Subject: Application for Permit Modification to the Section 404 Individual Permit and Section 401 Water Quality Certification for Construction of extension of NC 43 from south of NC 55 to north of US 17. Craven County. State Project No. 6.804857. TIP No. R-4463. Debit \$570 from WBS 35601.1.1.

The purpose of this letter is to request a modification to the US Army Corps of Engineers (USACE) Section 404 Individual Permit and NC Division of Water Quality (NCDWQ) Section 401 Water Quality Certification. The North Carolina Department of Transportation (NCDOT) is currently constructing the extension of NC 43 from NC 55 to US 17. The project, located west of New Bern in Craven County, is referred to as the NC 43 Connector (Bosch Boulevard) and is approximately 4.5 miles in length. A Section 404 Permit (Action ID 2007-02231-125) was issued on November 19, 2007 and Water Quality Certification issued (WQC No. 3673) on September 21, 2007. The project has been split into two sections, Section A and Section B. Section B has been let and construction has begun.

Summary of Changes

Table 1. Additional Permanent Jurisdictional Impacts for R-4463B

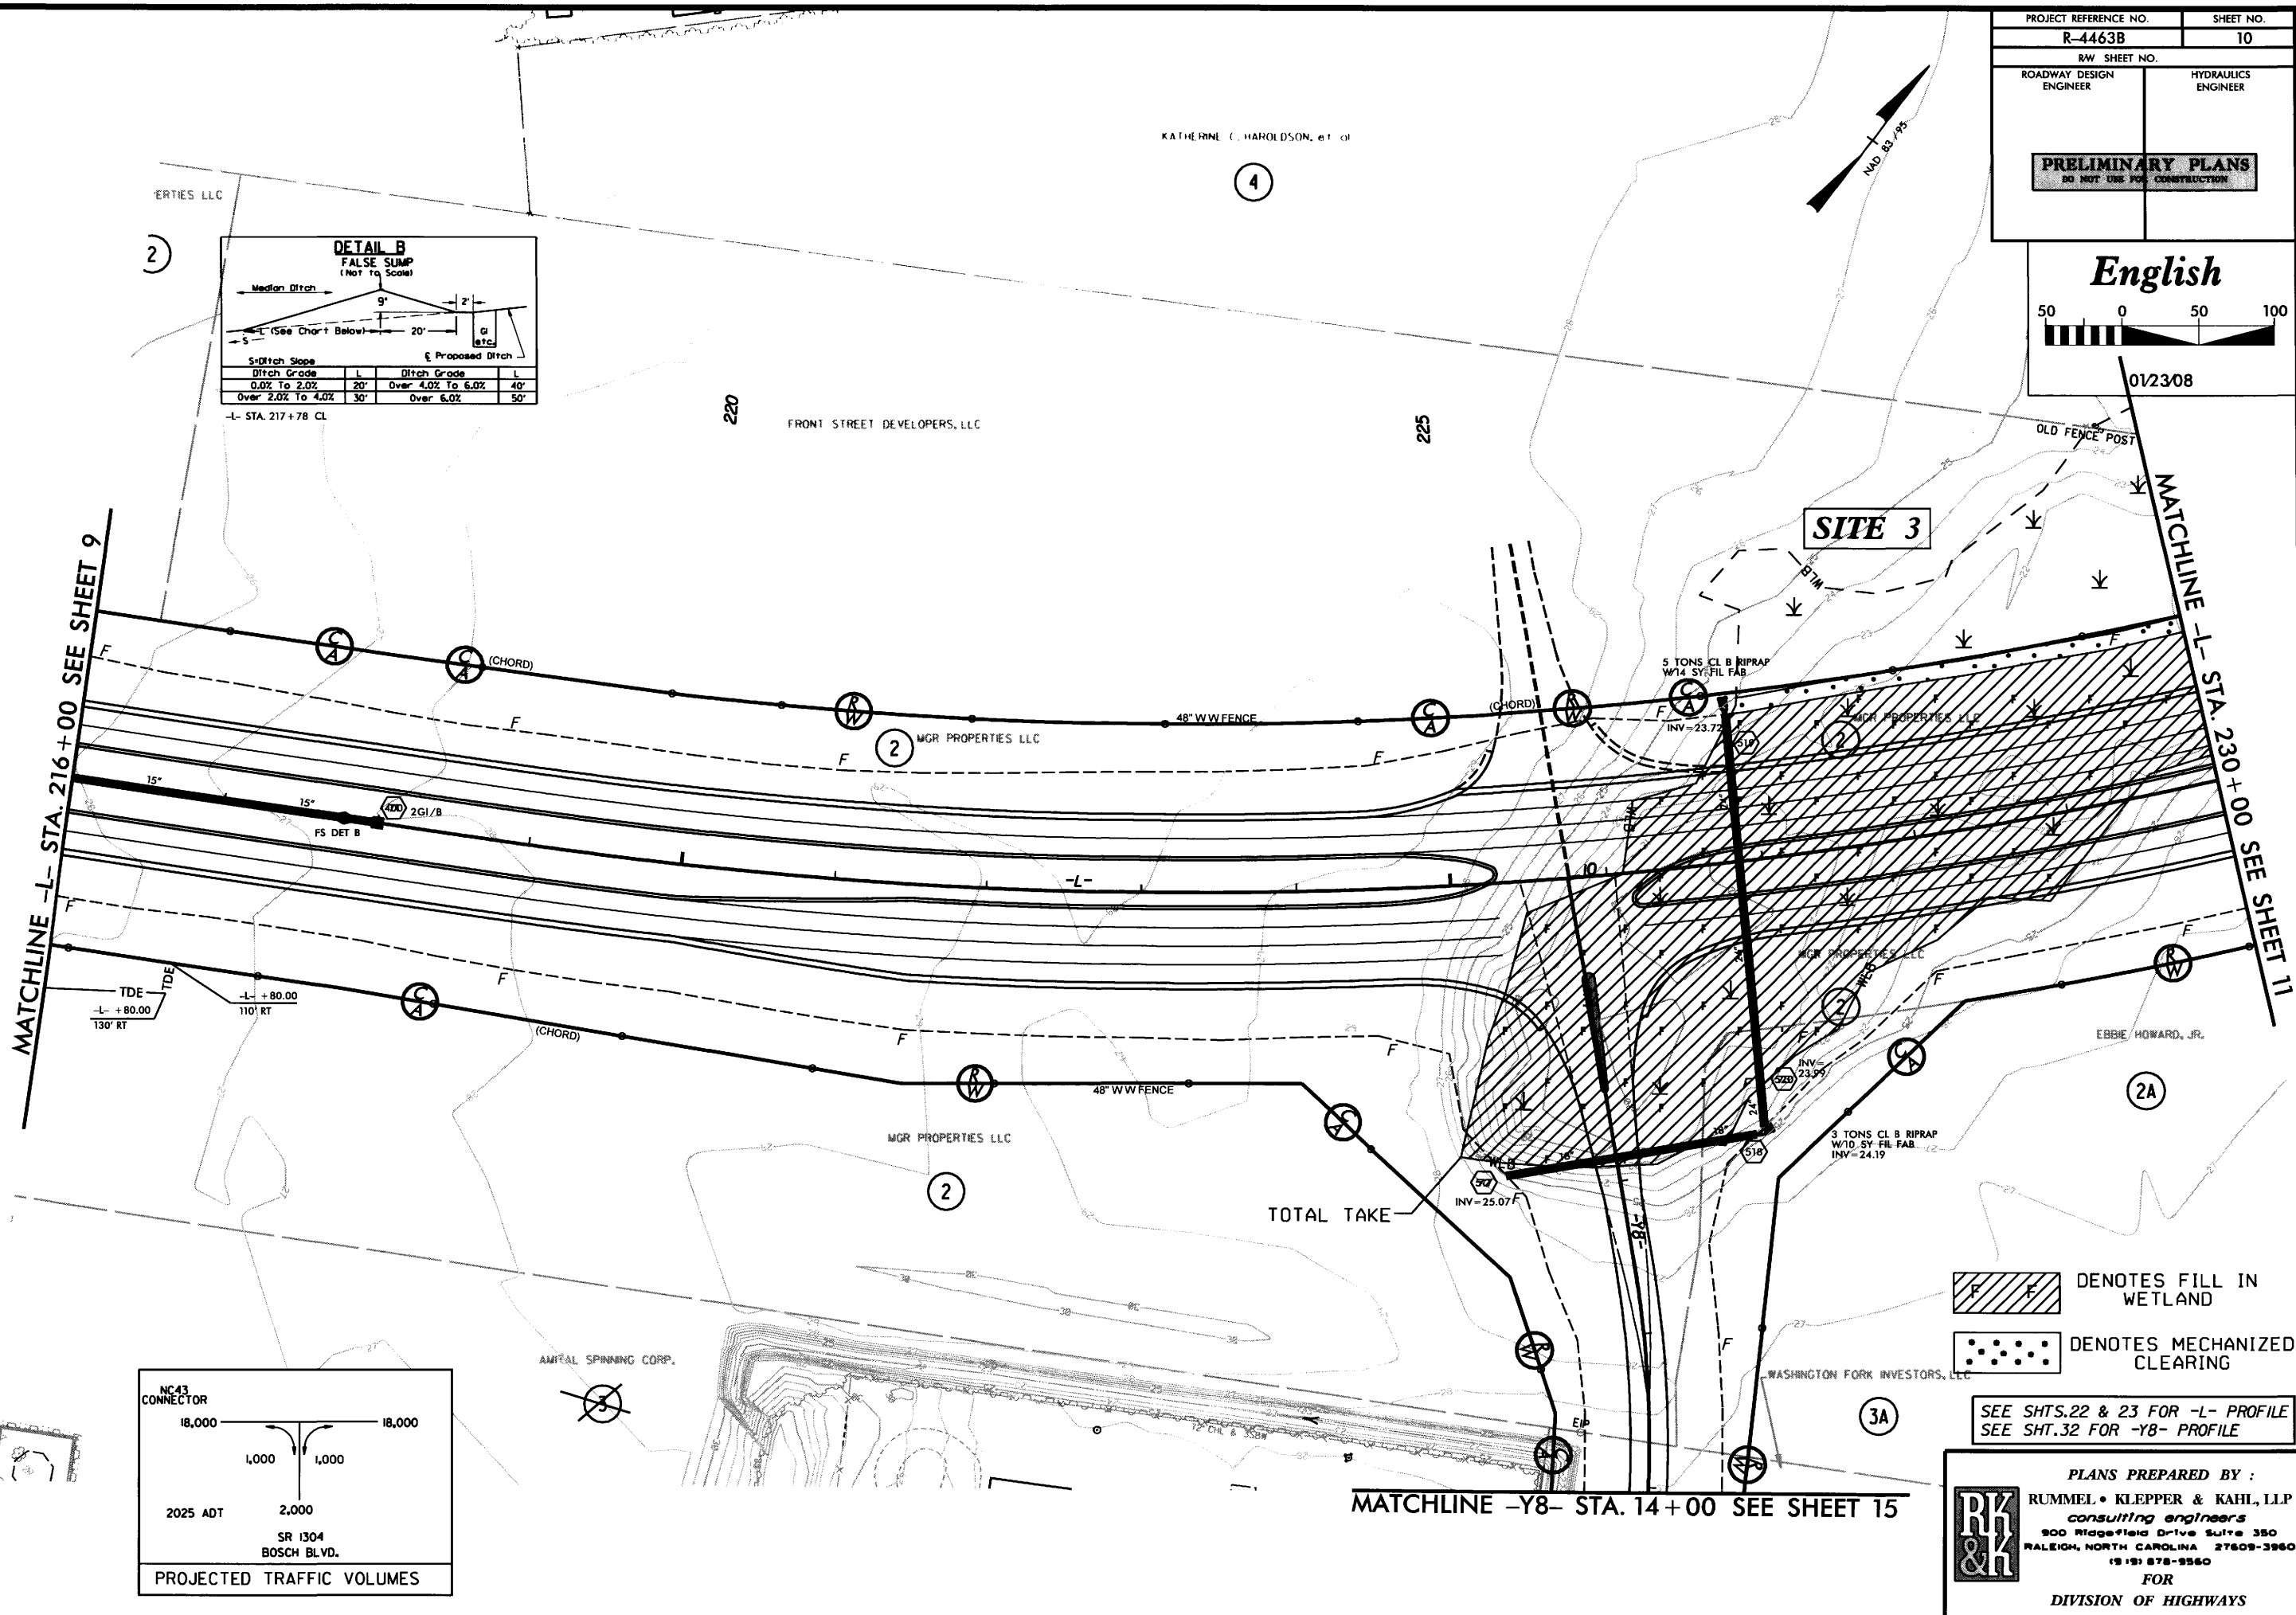
REVISIONS
February 4, 2008: Construction revision #2 - Added right turn lane opposite -Y8-

PROJECT REFERENCE NO. R-4463B	SHEET NO. 11
RW SHEET NO.	
ROADWAY DESIGN ENGINEER	HYDRAULICS ENGINEER

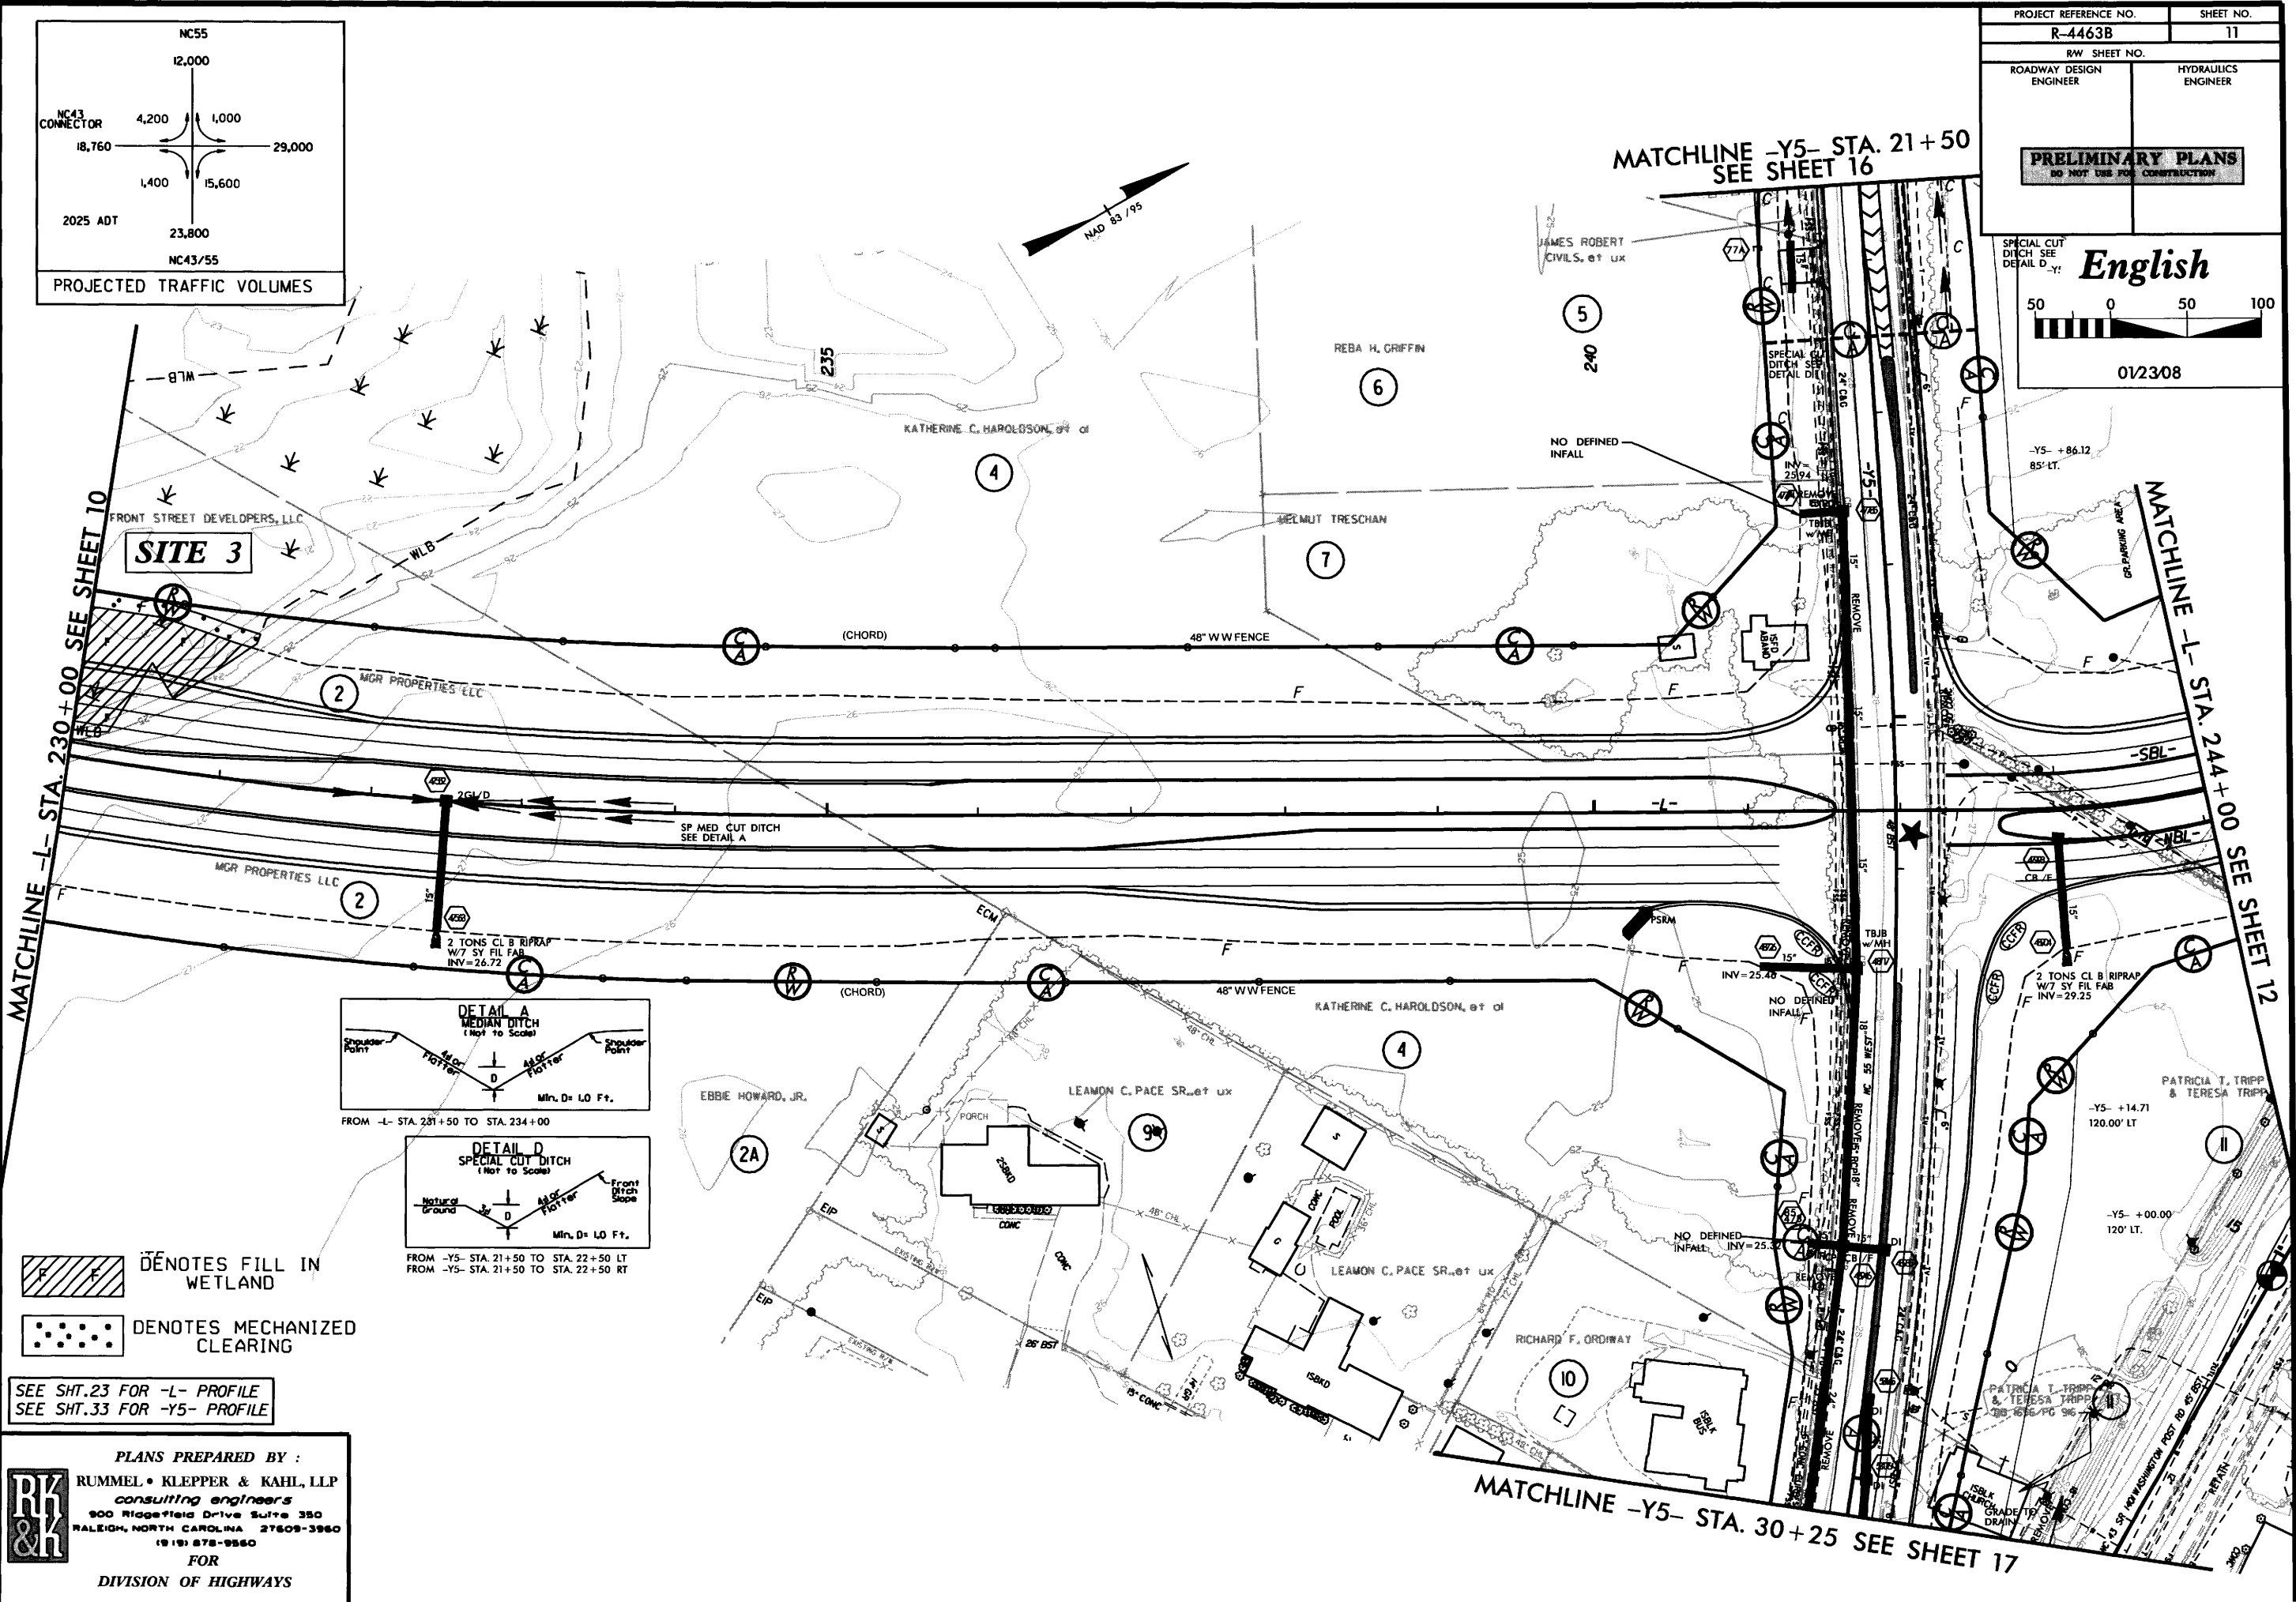
REVISIONS
February 4, 2008: Construction revision #2 - Added right turn lane opposite -Y8-

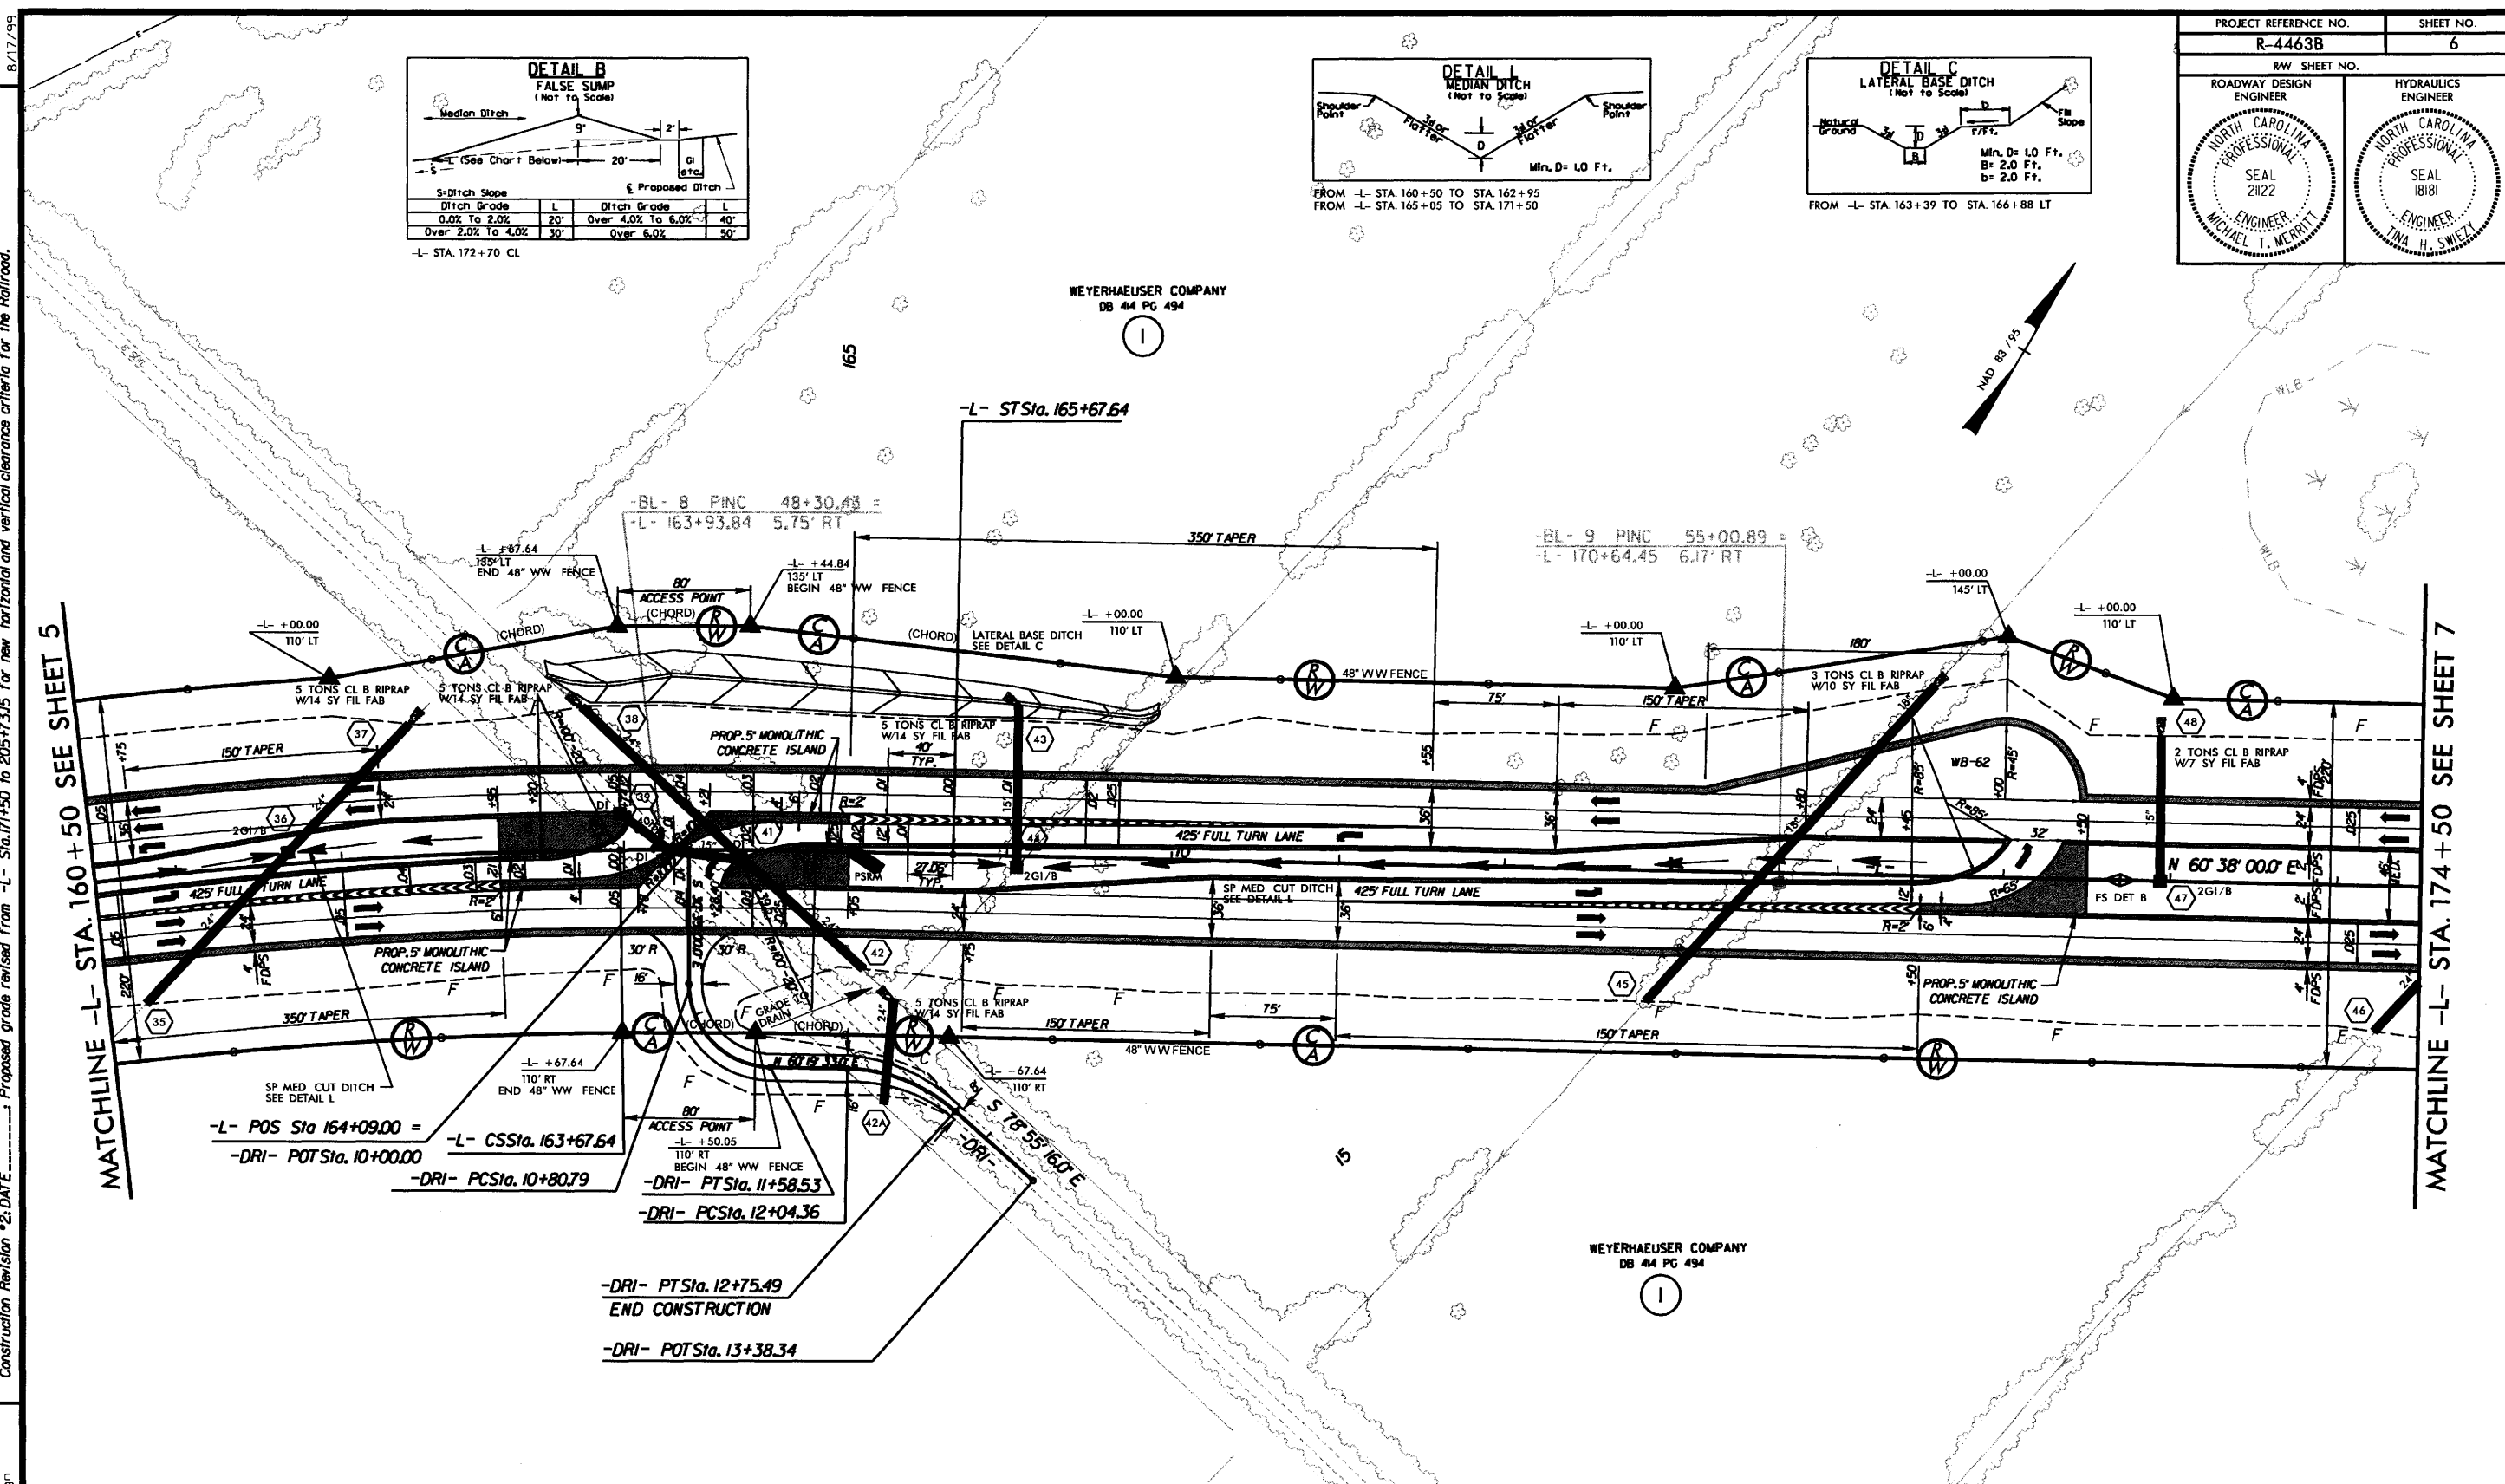
Construction Revision #2, DATE: Proposed grade revised from -L- Sta. 171+50 to 205+73.15 for new horizontal and vertical clearance criteria for the Railroad.
